October 25, 2012

ZS-2012-0448

Zion Nuclear Power Station, Units 1 and 2
Facility Operating License Nos. DPR-39 and DPR-48
NRC Docket Nos. 50-295 and 50-304

Subject: Request for Amendment to Approve Methods of Analysis, use of the Upgraded Fuel Handling Building Crane System as a Single-Failure Proof Crane and Approval of a NUREG 0612 Compliant Heavy Loads Handling Program

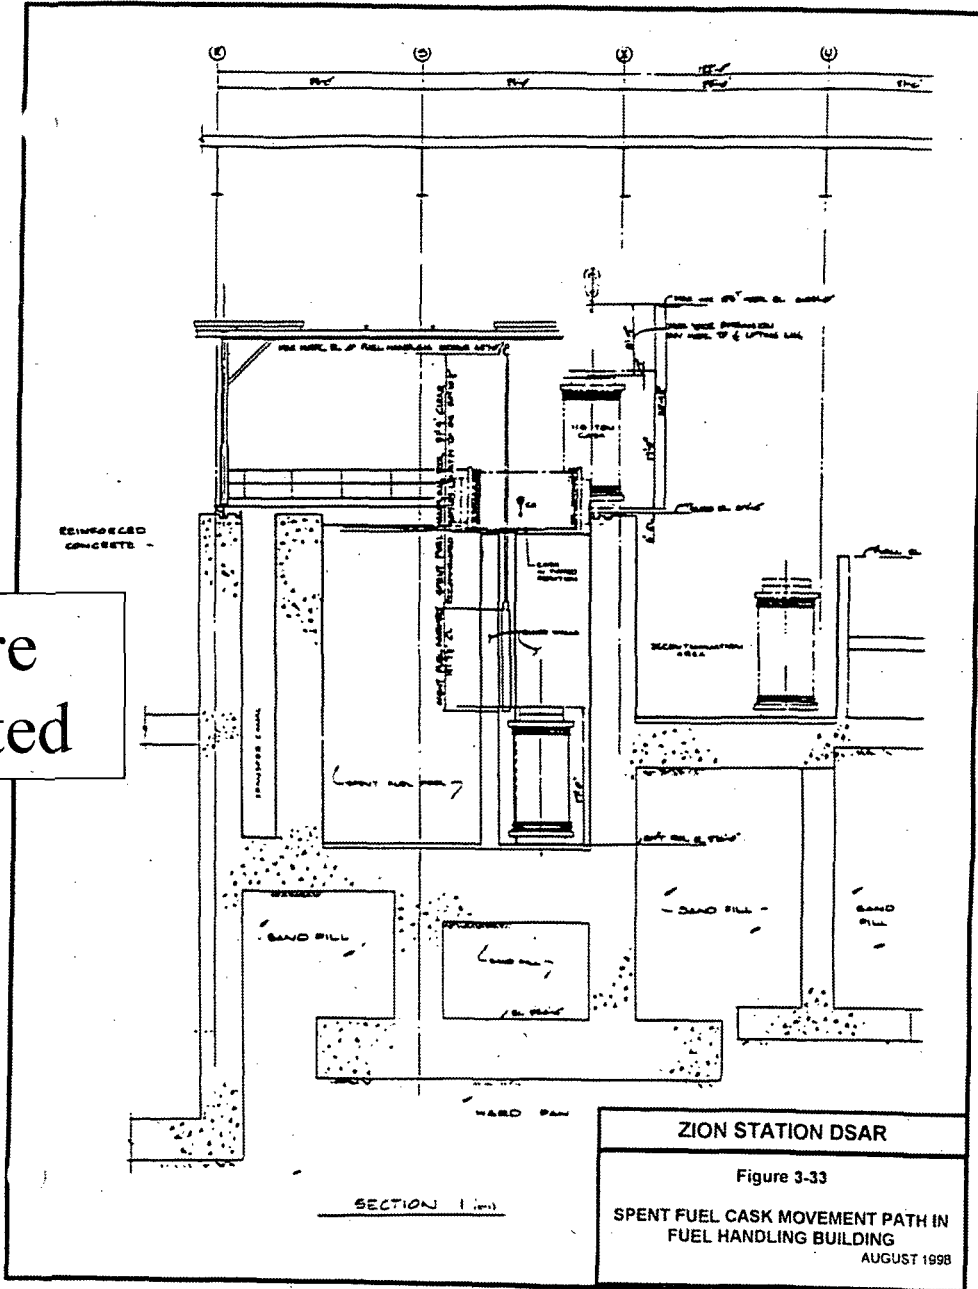
Figure Deleted

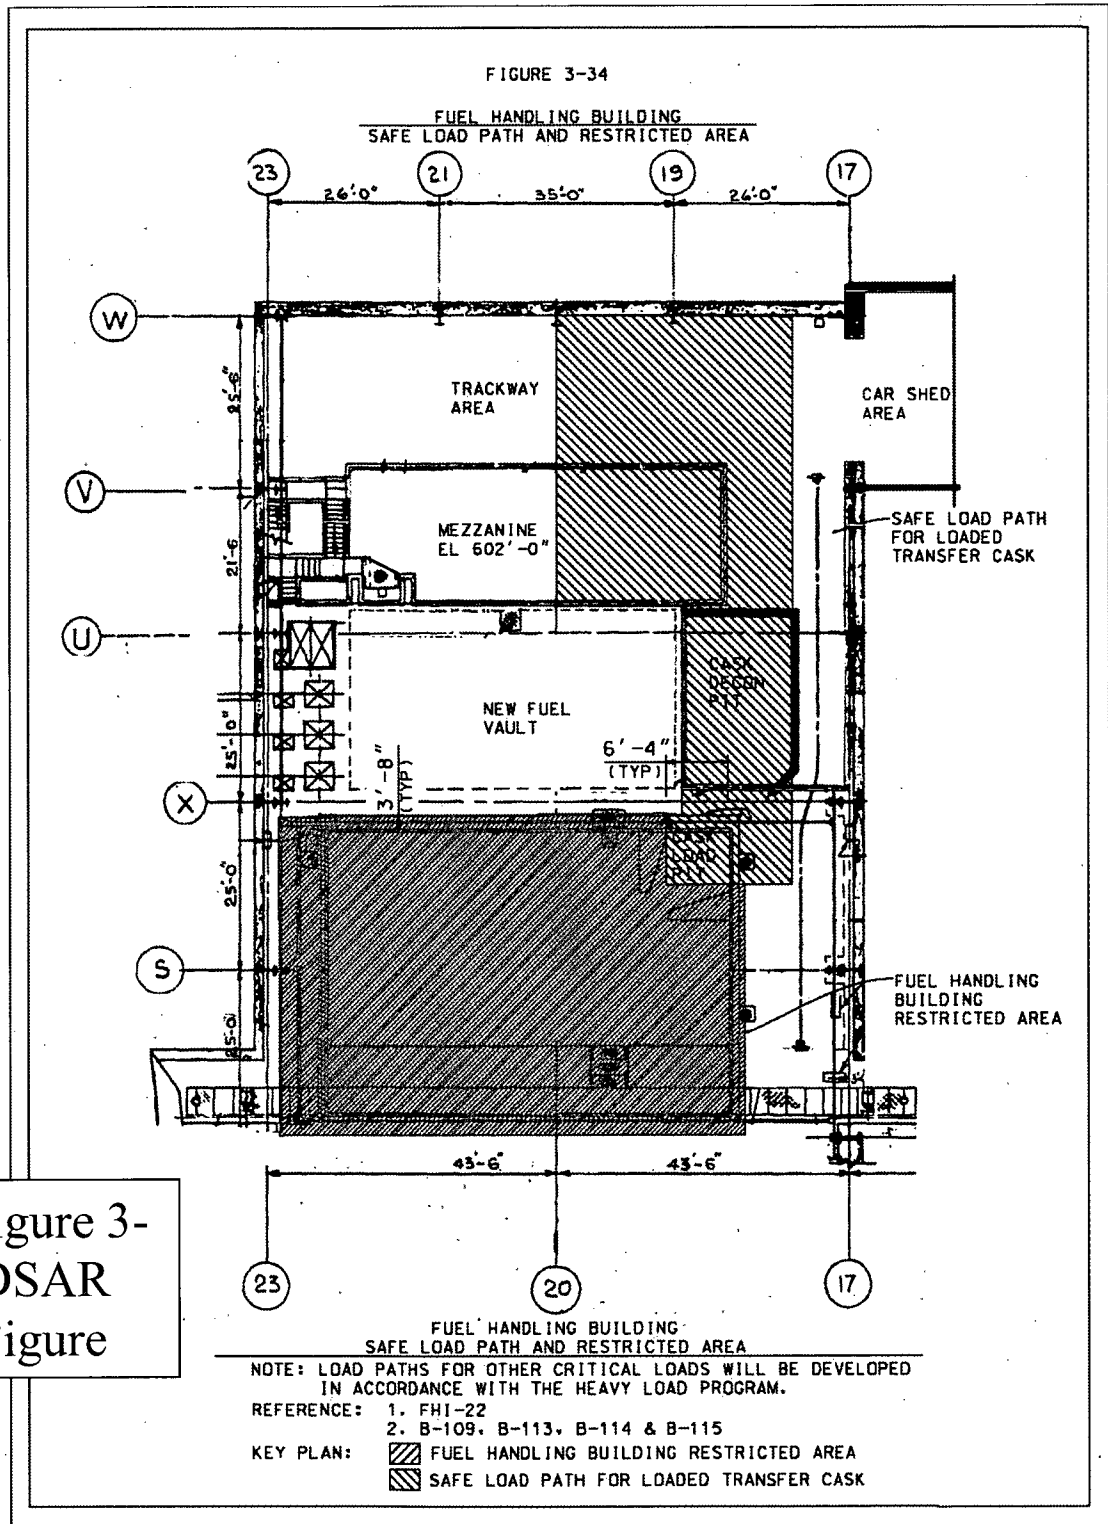
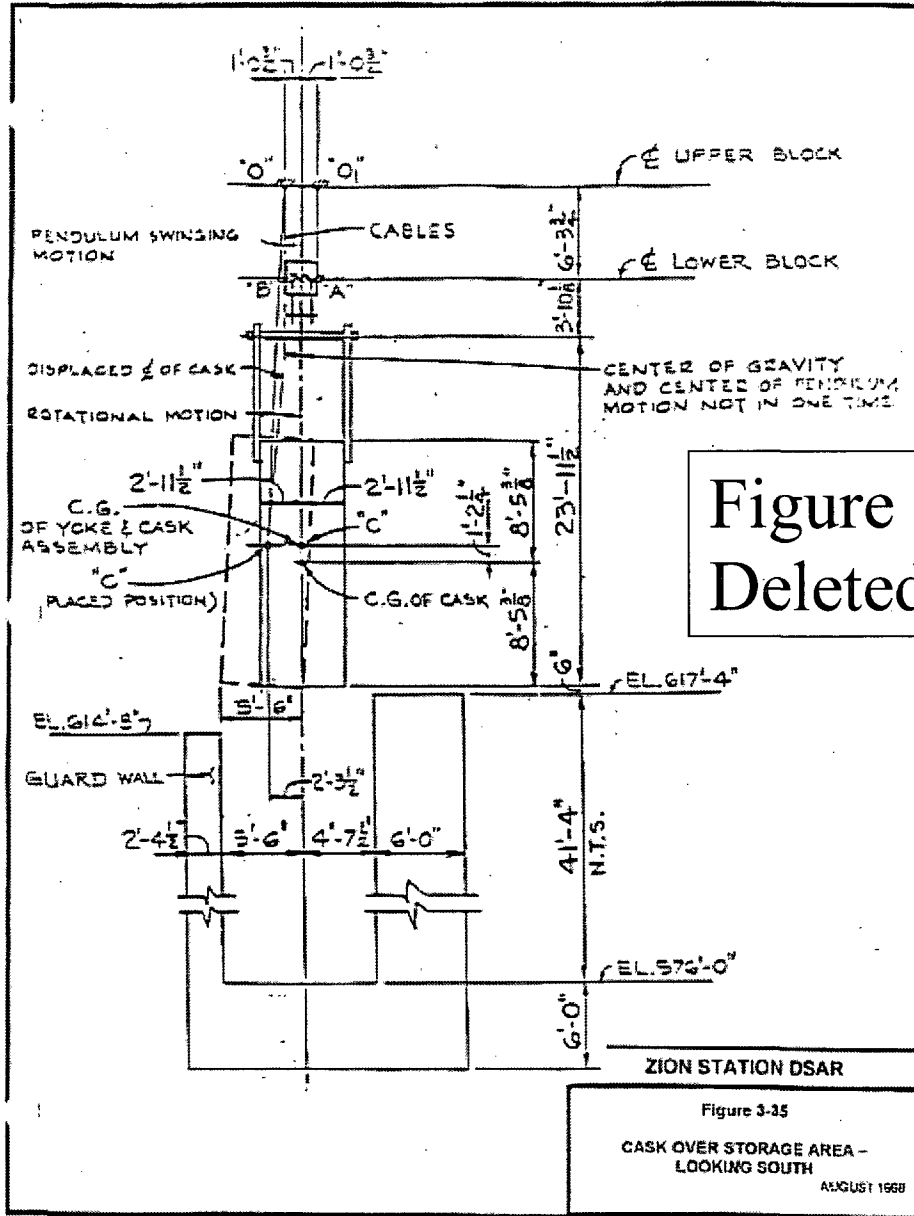
Replace Figure 3-34 in the DSAR with this Figure

The safe load path for handling the loaded cask will be shown in revised DSAR Figure 3-34. Handling of the MTC will be performed using a specially designed yoke as specified by NAC and described in the MAGNASTOR Safety Analysis Report. Safe load paths for other lifts listed above will be controlled as required by the Heavy Loads Program attached.

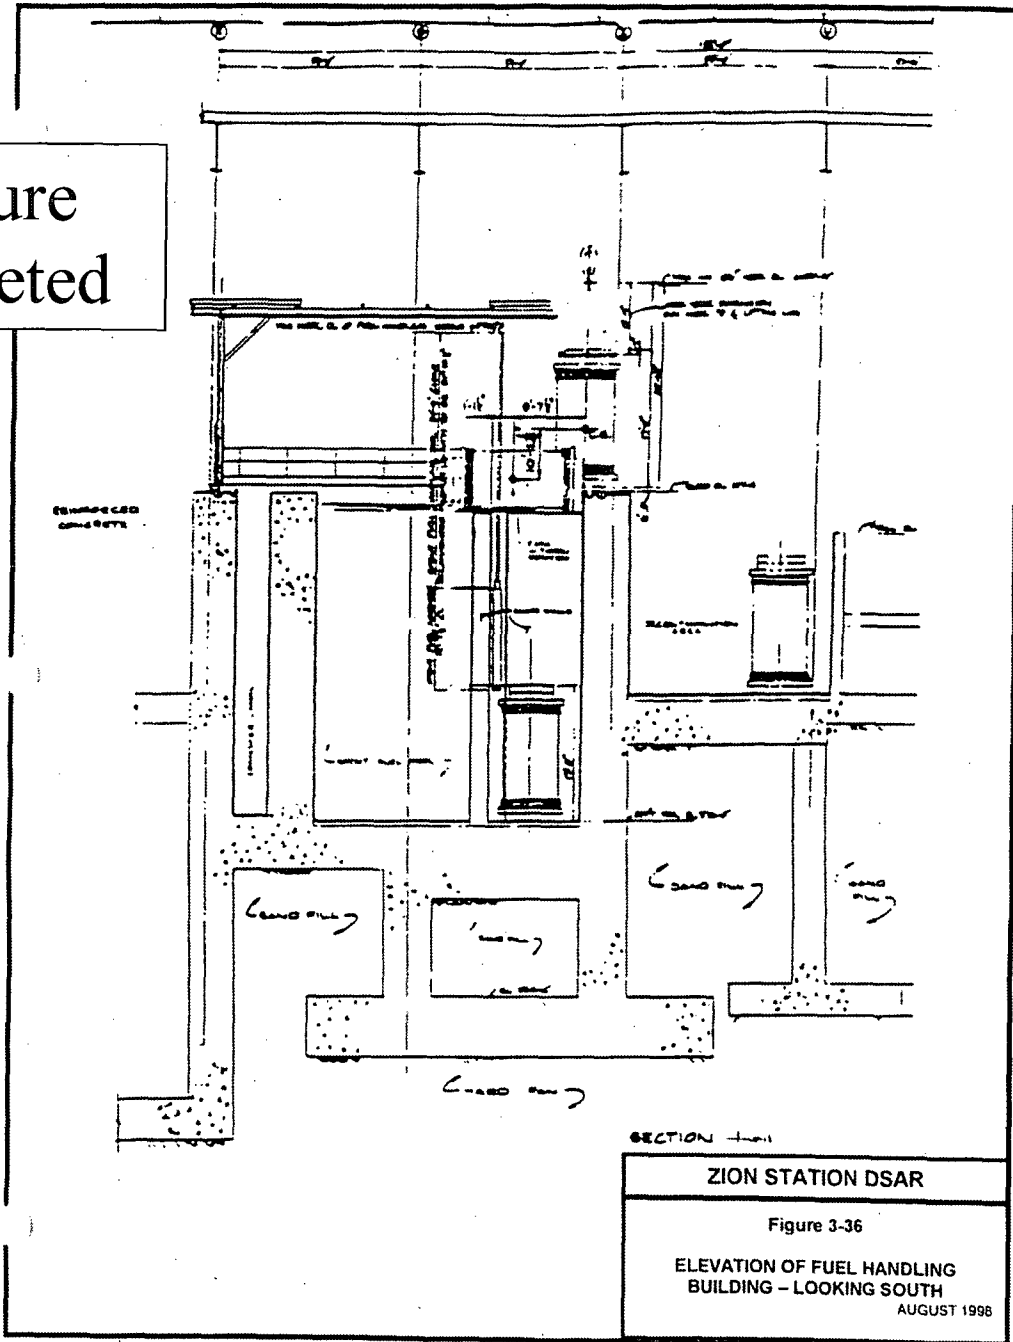
Figure Deleted
